Carter® Ground Fueling

PN18032564803

Product News Bulletin

Field Modification of the Vent Port

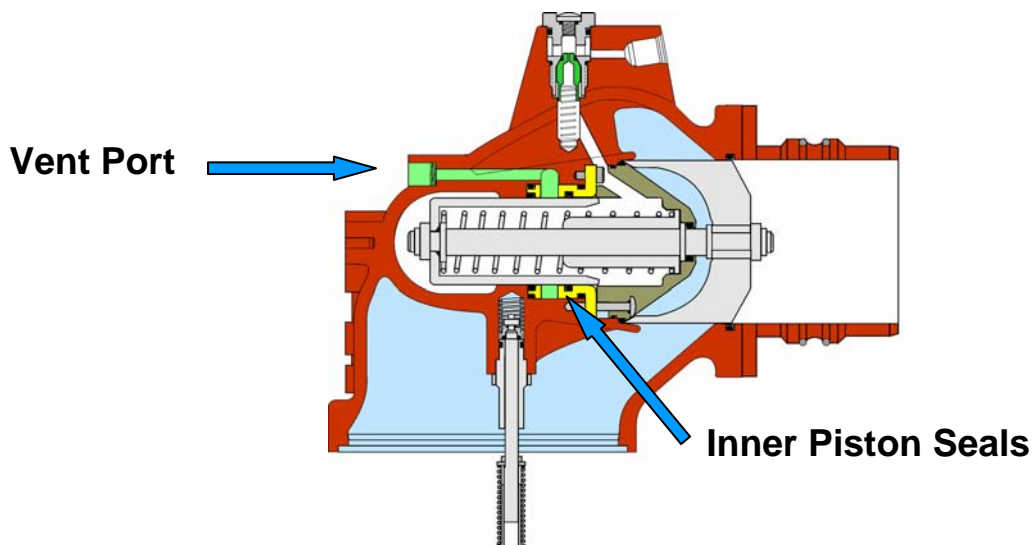
All Carter Ground Fueling hydrant couplers, except for the 60600 series of couplers, include a vent port (please review the image below). This vent port is intended to allow any fuel that leaks by the inner piston seal to be exhausted. This is done to prevent cross-contamination of the air reference pressure with fuel in air operated couplers, including the 64800, 64801, 64900 and 60700-1. This vent is also present in fuel reference pressure operated couplers, including the 64803, 64903 and 64702. The purpose of this vent on these couplers is to act as a tell-tale if the inner piston seals were to become damaged or excessively worn and begin to leak. We would also note that, even with the seals in good condition, there may be some small amount of leakage. This small amount of leakage will manifest itself as a stain around the vent port or minor weeping. The seals around the inner piston will not remove all of the fuel from the surface of the piston. When the unit is in operation the inner piston will oscillate, opening and closing to maintain the downstream pressure. As this occurs small

amounts of fuel will be wiped off the piston and remain in the void area between the inner piston seals. Given enough time, this fuel will accumulate and the slight weeping or staining of the area around the vent port can occur. This phenomenon is more common on fuel reference operated couplers as the amount of fuel that can be deposited in the void area between the inner piston seals is effectively doubled. However, as cross-contamination in a fuel-over-fuel system is not a concern, tapping and plugging the vent port may prevent a coupler from being unnecessarily removed from service due to a perceived leak. We have recently completed testing and determined that this vent may be plugged on fuel reference operated couplers, including the 64803 and 64903. **The vent port on the 64702 can not be plugged due to the shape of the vent port. This field modification should not be accomplished on air reference operated couplers as this would circumvent the primary purpose of the vent to prevent cross contamination of the air reference pressure system.**

Not all fuel reference operated couplers will require this field modification. We have recently modified new production units to include 1/4" NPT threads in the vent port. All 64803 hydrant couplers with serial number 390 and higher and all 64903 hydrant couplers with serial number 101 and higher will include this upgrade. For those hydrant couplers, remove the filter and retainer and install a pipe plug as described above.

The first step will be to inspect the raised area around the vent port opening. You may find that the original vent port is not centered in this raised area. Measure the area with the thinnest wall thickness. If the thinnest portion is less than .100", that housing can not be modified. For those couplers with a wall thickness greater than .100", remove the pressure control elbow from the coupler lower half and remove all internal components of the control elbow, leaving the vent port filter and retainer in place. The current hole is the appropriate size to accept a 1/4" NPT tap. Obtain a good quality 1/4"-18 NPT tap. You will note that the depth of the hole up to the filter disc will be deep enough for 1/4" NPT threads. Some brands of tap will have a tapered point on the leading end. Depending on the brand of tap that you have it may be necessary to grind this tapered point flat.

Measure the depth of the hole and mark the tap, measuring from the leading end. Insert the tap in the hole and, while pressing inward, begin to screw the tap in. Use liberal amounts of thread cutting oil intended for use with aluminum - Soluble, Light Base, or Lard Oil, or Mineral Oil w/Lard, or Light Oil. Remove the tap frequently and remove metal shavings to prevent build up of metal shavings from damaging the threads. Continue to screw in the tap up to the measured mark. Remove the filter screen and retainer. Remark the tap for this new depth and tap to that depth. Clean the threads and insert a 1/4" pipe plug to check the threads. Use an appropriate material pipe plug (stainless steel is preferred). The preferred type of pipe plug will have a low profile and will include a recessed hex socket similar to image above. Whatever type of plug is used, make sure that it has tapered threads. Some pipe plugs include straight pipe threads similar to a screw. The plug should screw into the threaded hole approximately 1/4 to 1/3 its threaded length with little effort. Some brands of NPT taps work better on blind holes than others. Bottom taps for NPT threads are not available. Some taps will have

a longer cutting edge past the first cutting thread than others. It may be necessary to grind more material off the leading end to obtain the appropriate thread depth. Use caution not to over tighten the tap. If the tap bottoms out in the hole and you continue to turn it, you can remove all of the threads from the hole.

Clean the housing and vent port threads and pipe plug to remove all metal shavings and cutting oil. Apply a good quality anaerobic type thread sealant such as Hercules Block. Insert the pipe plug and tighten. There are no torque recommendations for tapered threads. Do not over tighten. This is a tapered pipe plug in a tapered hole. Over tightening can crack the housing. The best approach is to tighten to a good snug fit and check for leaks. If the joint does leak it will be necessary to remove the plug and clean off all thread sealant. An anaerobic thread sealant will set up quickly when in contact with certain active metals such as aluminum. Apply new sealant to pipe plug and reinstall a little tighter.

We recommend that this pipe plug be removed monthly to check for excess leakage. To check for excess leakage remove the pipe plug in the vent port and turn the coupler over to drain any residual fuel. Connect the hydrant dispenser to a suitable test facility to recirculate product. Activate the deadman to flow product. Observe the vent port for leakage for one minute. If fuel begins to come out of the vent port before one minute has passed, this would indicate that the inner piston seals need to be replaced. If fuel does not come out of the vent port in one minute, clean and dry the threads of the port and the pipe plug and reinstall per the instructions above.
